SUBJECT: CHANGES TO TECHNICAL SPECIFICATIONS TO ADD A TRANSFER SWITCH
AND MAKE ADMINISTRATIVE CHANGES TO CORRECT ERRORS

RE: GRAND GULF NUCLEAR STATION, UNIT 1

Amendment No. 19
License No. NPF-29

SAFETY EVALUATION BY THE OFFICE OF NUCLEAR REACTOR REGULATION
SUPPORTING AMENDMENT NO. 19 TO FACILITY OPERATING LICENSE NO. NPF-29
MISSISSIPPI POWER & LIGHT COMPANY
MIDDLE SOUTH ENERGY, INC.
SOUTH MISSISSIPPI ELECTRIC POWER ASSOCIATION
GRAND GULF NUCLEAR STATION, UNIT 1
DOCKET NO. 50-416

**FIGURE 5.1.1-1
EXCLUSION AREA AND GASEOUS EFFLUENT RELEASE POINTS**

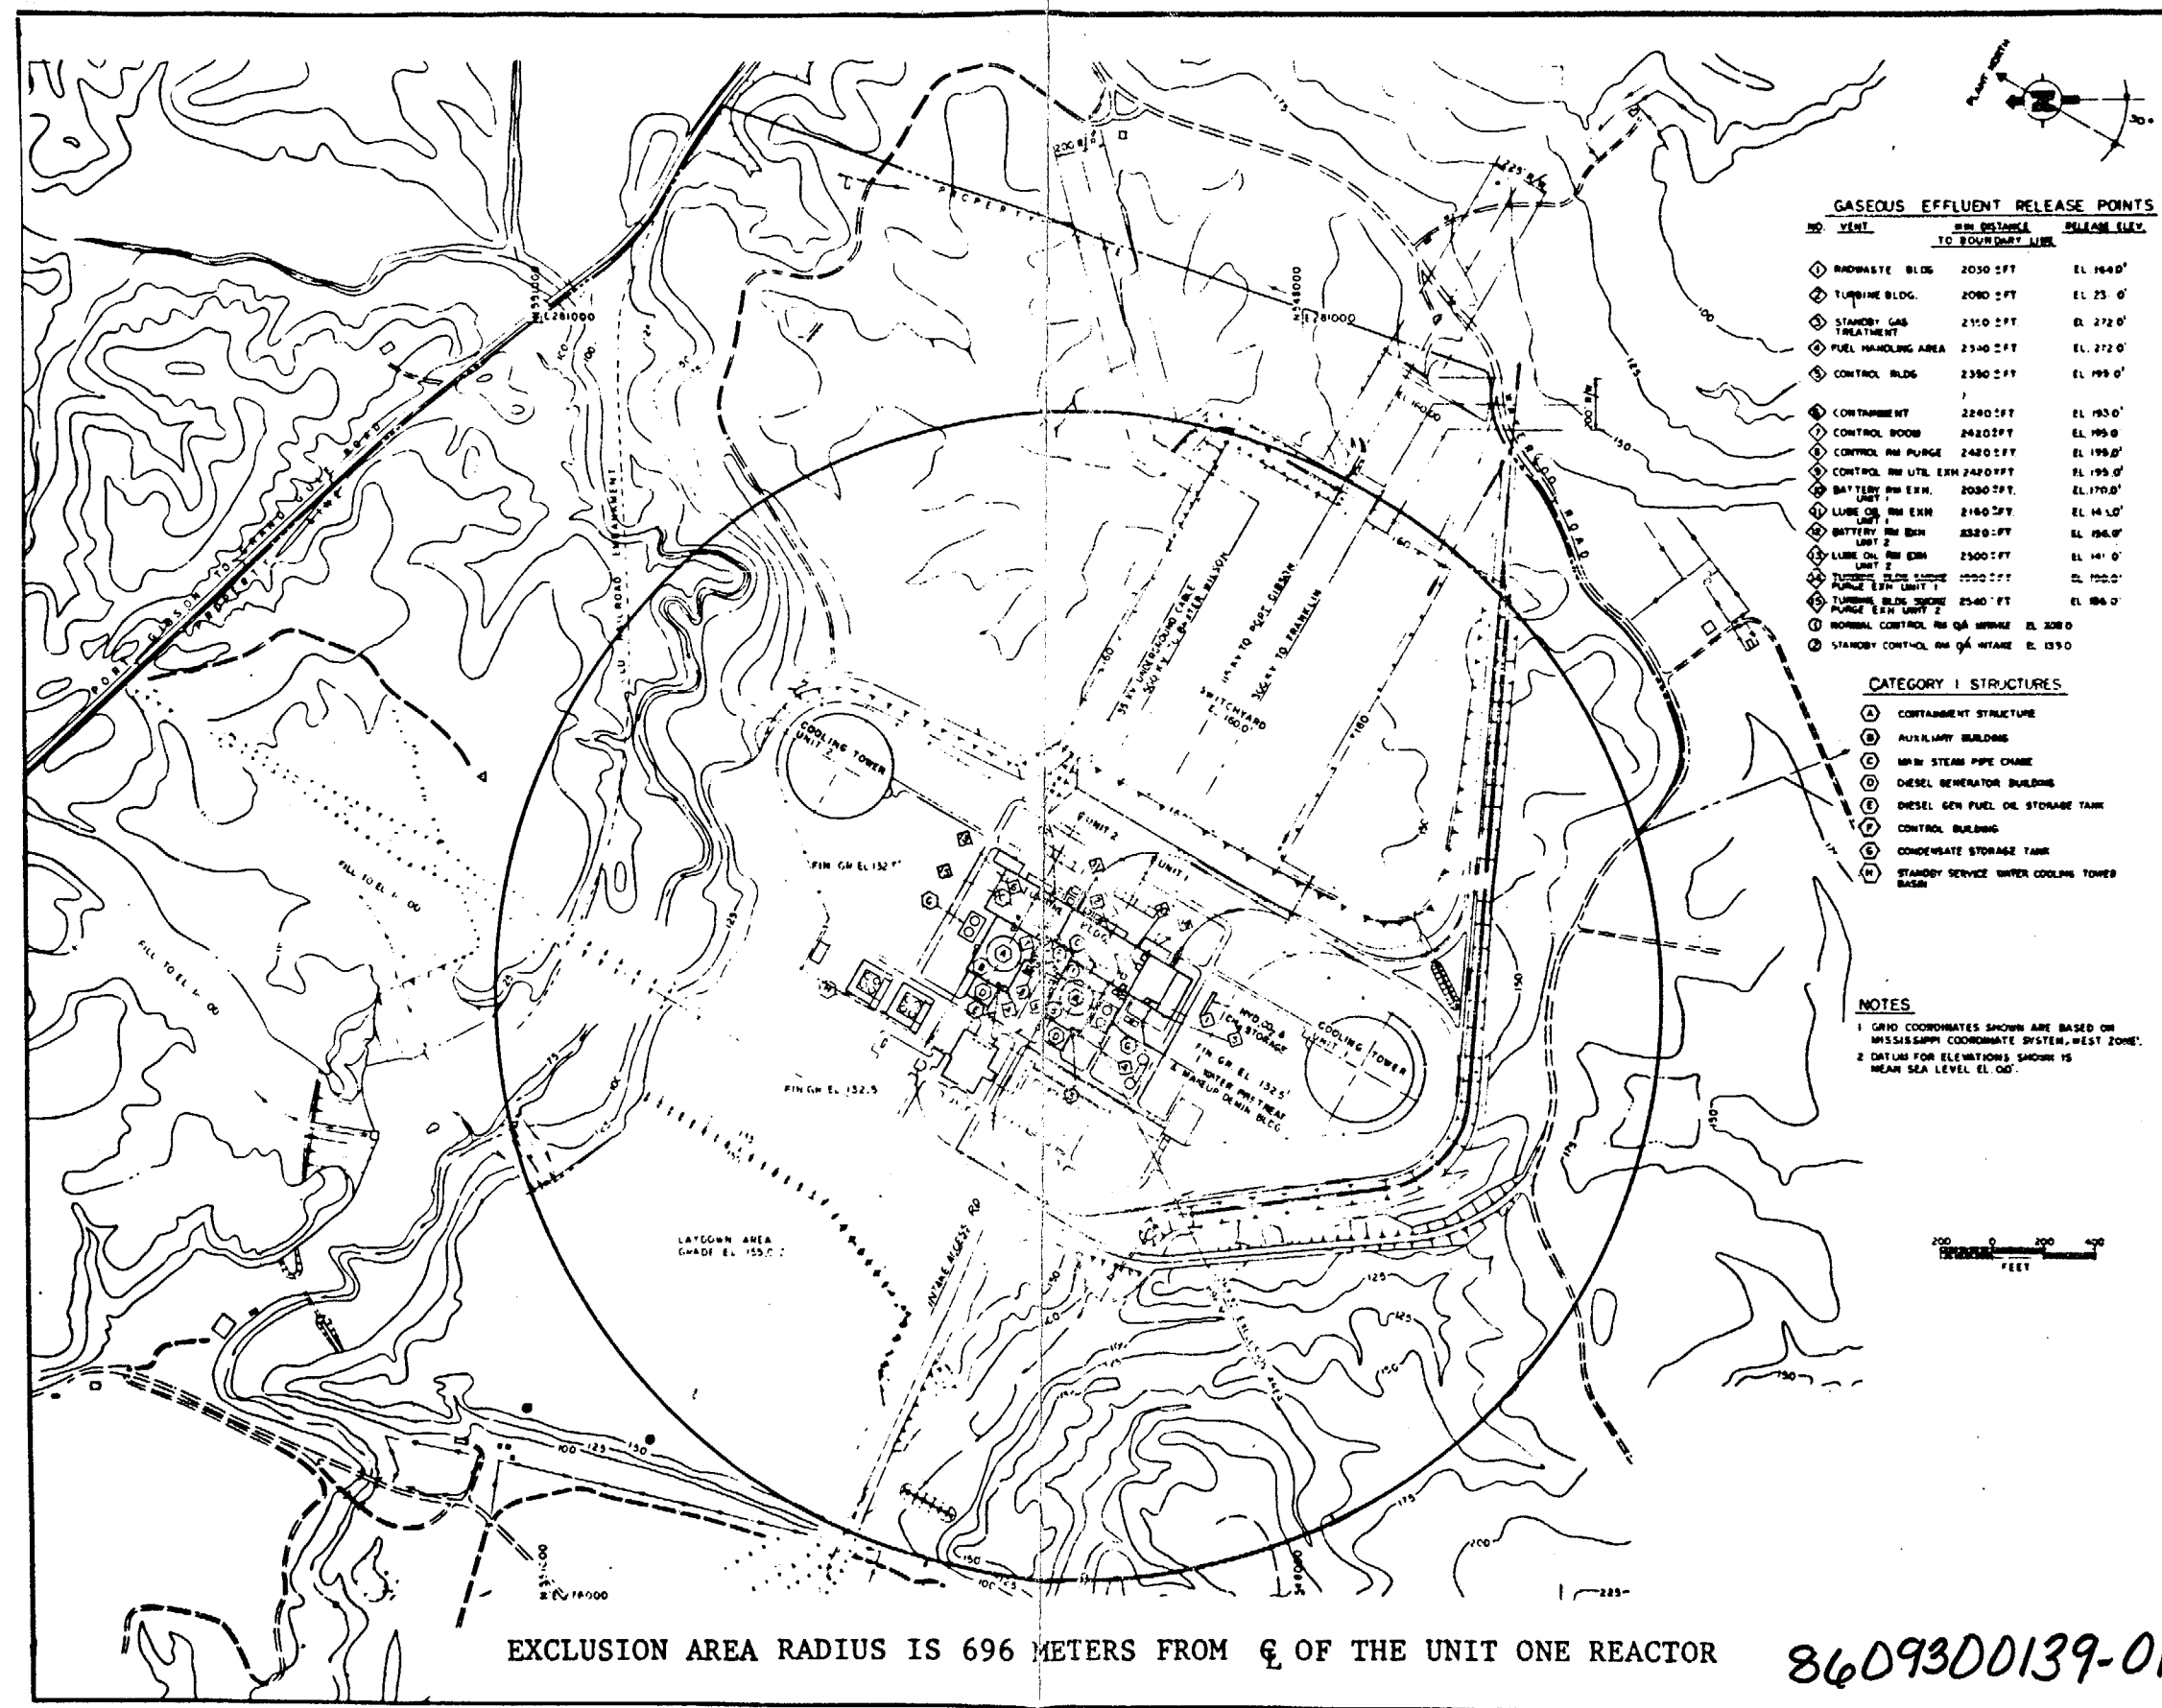
Figure 5.1.1-1 of the Technical Specifications is intended to identify the exclusion area and gaseous effluent release points for Grand Gulf Nuclear Station (GGNS), Unit 1. As currently depicted in Figure 5.1.1-1, the northern half of the exclusion area for Grand Gulf Unit 1 is centered on the Unit 2 reactor, and the southern half of the exclusion area is centered on the Unit 1 reactor. The minimum exclusion area boundary distance is 696 meters. The licensee has proposed to replace the current envelope of the exclusion areas for both reactors with an exclusion area for Grand Gulf Unit 1 centered solely on the Unit 1 reactor with a radius of 696 meters. For operation of Unit 1 only, the proposed change will not affect the results and conclusions presented in Section 11.2.2 Gaseous Waste Treatment System and Section 15.3, Radiological Consequences of Design Basis Accidents, of our Safety Evaluation Report (NUREG-0831, dated September, 1986) which assumed a minimum exclusion area boundary distance for the Technical Specifications for GGNS Unit 1, since Unit 2 is not in operation.
